| 10/573,057 | 05/17/2007 | David Wilson | 2960-97005 | 8961 |

| Office Action Summary | Application No. 10/573,057 | Applicant(s) WILSON, DAVID |

DETAILED ACTION

Figure A.

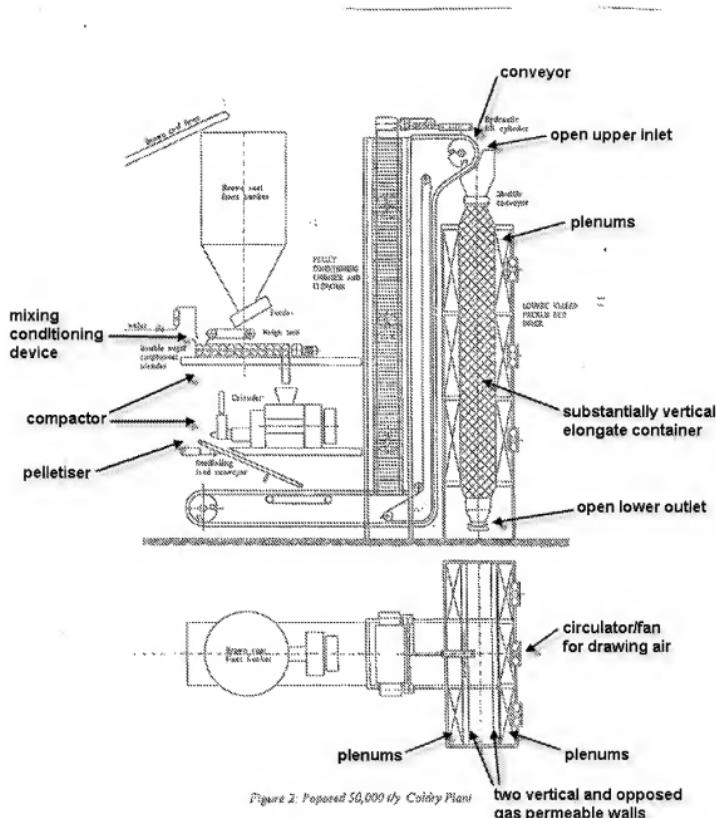
9. Regarding claims 1, 4-9, 11-13, 17-19, 21, and 24, Wilson et al. discloses a dryer (fig. 2) for drying pellets containing brown coal (page 3, line 3-page 4, line 13 describing a dryer for drying brown coal pellets), comprising at least one substantially vertical elongate container (fig. 2 and Figure A below) having: an open upper inlet (fig. 2 and Figure A below) for receiving a charge of moisture and brown coal containing pellets (fig. 2 and Figure A below showing an open upper inlet of the dryer for receiving moist brown coal pellets, page 3, line 3-page 4, line 13 describing drying moist brown coal pellets); an open lower outlet (fig. 2 and Figure A below) for discharging dried brown coal containing pellets ("Dried pellets are extracted from the bottom")

page 4, lines 1-2), whereby said pellets travel under the influence of gravity from said inlet (fig. 2 and Figure A below) to said outlet (fig. 2 and Figure A below) in a substantially continuous manner (“slowly descending mass of pellets” page 4, lines 1-13); two substantially vertical and opposed gas permeable walls (fig. 2 and Figure A below) through which a drying gas can pass to contact said pellets (“dried by means of a crossflow of air” page 3, line 31-page 4, line 13); . . . ; said dryer also comprising plenums (fig. 2 and Figure A below) on exterior surfaces of said gas permeable walls (fig. 2 and Figure A below), covering ingress and egress openings (“long vertical walls, which are perforated” page 4, lines 3-4) within . . . said gas permeable walls (fig. 2 and Figure A below showing plenums covering the gas permeable walls through which a crossflow of air passes), wherein the plenums (fig. 2 and Figure A below showing plenums divided into zones) are divided into zones . . . , wherein ingress openings and egress openings (“long vertical walls, which are perforated” page 4, lines 1-4 describing a crossflow of air passing through the perforated walls) are respectively provided within said permeable walls (fig. 2 and Figure A below), wherein a plenum (fig. 2 and Figure A below showing plenums on the left side of the container where the plenums on the right show fans used to draw the drying air) covering ingress openings comprises at least one inlet (“Drying air enters at one side, is drawn through the slowly descending mass of pellets, and discharged from the opposite side” page 4, lines 4-5 where it is implicit that the plenums on the left side would have at least one air inlet) and a plenum (fig. 2 and Figure A below showing plenums on the right side of the container) covering egress openings comprises at least one outlet (“discharged from the opposite side” page 4, lines 4-5 where it is implicit that the plenums on the right side would have at least one air outlet), wherein drying gas is drawn (“Drying air . . . is drawn through the slowly descending

mass of pellets" page 4, lines 4-5) into the at least one inlet by a circulator (fig. 2 and Figure A below), wherein the circulator is an induced draft fan (fig. 2 and Figure A below, "Drying air . . . is drawn" page 4, lines 4-5), a drying plant (fig. 2, "plant layout in Fig. 2" page 4, lines 3-13) comprising: (a) a conditioning bed ("Pellet Conditioning Chamber and Elevator" fig. 2, page 3, lines 17-23 describing surface conditioning moist brown coal pellets in an elevating tray system where the trays would form a bed of pellets for conditioning) for subjecting moisture and brown coal containing pellets to surface conditioning; (b) at least one conveyer (fig. 2 and Figure A below) for conveying said surface conditioned pellets to an inlet (fig. 2 and Figure A below) of a dryer according to claim 1; . . . , further comprising a compactor (fig. 2 and Figure A below) for production of brown coal containing compacted bodies (page 3, lines 3-16 describing compacting brown coal into pellets), wherein the compactor (fig. 2 and Figure A below) comprises a mixing/conditioning device (fig. 2 and Figure A below and fig. 1 showing mixing/blending) and a pelletiser (fig. 2 and Figure A below and fig. 1 showing pelletising), a method (fig. 1 showing a coldry process) of drying brown coal which comprises introducing brown coal fines (fig. 1 showing brown coal and "brown coal fines bunker" fig. 2) into the compactor (fig. 1 showing mixing/blending and pelletising and fig. 2 and Figure A below showing the compactor) of the drying plant (fig. 2) according to claim 18, and wherein said plenums (fig. 2 and Figure A below) are located external to said substantially vertical elongate container (fig. 2 and Figure A below), except for wherein the gas permeable walls comprise a substantially continuous corrugated plate, wherein each corrugation comprises a supporting leg and a permeable leg angled with respect to each other, said permeable leg, of differing air stream properties, wherein the at least one outlet comprises at least one extract duct, wherein the

15. Regarding claims 20 and 25, Wilson et al. discloses a dryer (fig. 2) for drying pellets containing brown coal (page 3, line 3-page 4, line 13 describing a dryer for drying brown coal pellets) comprising at least one substantially vertical elongate container (fig. 2 and Figure A below) having: an open upper inlet (fig. 2 and Figure A below) for receiving a charge of brown coal containing pellets (fig. 2 and Figure A below showing an open upper inlet of the dryer for receiving moist brown coal pellets, page 3, line 3-page 4, line 13 describing drying moist brown coal pellets); an open lower outlet (fig. 2 and Figure A below) for discharging dried pellets of brown coal ("Dried pellets are extracted from the bottom" page 4, lines 1-2), whereby said

pellets travel under the influence of gravity from said inlet (fig. 2 and Figure A below) to said outlet (fig. 2 and Figure A below) in a substantially continuous manner ("slowly descending mass of pellets" page 4, lines 1-13); two opposing substantially vertical gas permeable walls (fig. 2 and Figure A below) through which a drying gas can pass to contact said pellets ("dried by means of a crossflow of air" page 3, line 31-page 4, line 13); . . . ; said dryer also comprising plenums (fig. 2 and Figure A below) on external surfaces of the gas permeable walls (fig. 2 and Figure A below) covering ingress and egress openings ("long vertical walls, which are perforated" page 4, lines 3-4) within . . . said gas permeable walls (fig. 2 and Figure A below showing plenums covering the gas permeable walls through which a crossflow of air passes), wherein the plenums (fig. 2 and Figure A below showing plenums divided into zones) are divided into zones . . . , and wherein said plenums (fig. 2 and Figure A below) are located external to said substantially vertical elongate container (fig. 2 and Figure A below), except for wherein the gas permeable walls comprise a substantially continuous corrugated plate, wherein each corrugation comprises a supporting leg and a permeable leg angled with respect to each other, said permeable leg, of differing air stream properties and wherein the direction of drying gas flow through the charge of brown coal containing pellets is reversed from one plenum zone to an adjacent plenum zone; the dryer comprising lateral internal membrane walls joining opposing gas permeable walls that divide the dryer into a plurality of adjacent cells. However, Pietsch teaches gas permeable walls (1, 2, fig. 1, page 1, lines 34-41 describing gas permeable walls 1 and 2) comprise a substantially continuous corrugated plate (figs. 1-3 showing the walls 1 and 2 as substantially continuous corrugated plates), wherein each corrugation comprises a supporting leg (fig. 3 showing a supporting leg at 2) and a permeable leg (fig. 3 showing a
